MAS004653 RU 25-05

# Rapid Update 770 Grecale Folgore - Additional checks

DATE: March 28, 2025

This Rapid Update communication provides a general update to the MAS004444 RU #770 technical procedure. We are now requesting that the Valve B check be repeated **\*\*five times\*\*** instead of once. Additionally, an improvement has been implemented on the MD-EVO to make the test cycle easier to perform.

## CPV2 – Valve “B”

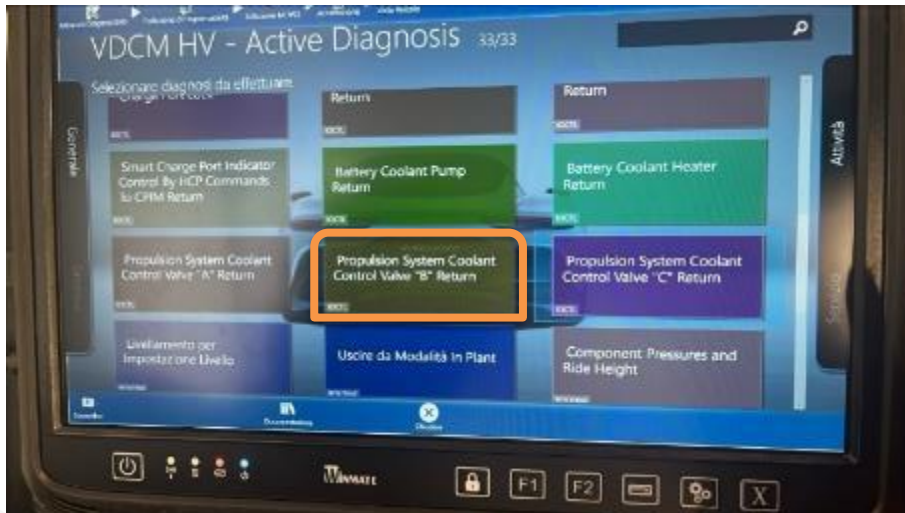
- Perform the procedure for entering the values 100 and 0 as explained from step 10 to step 13 of this bulletin 5 times , taking care to wait at least 20 seconds between one command and the next.
- Wait 20 seconds before proceeding with valve C.
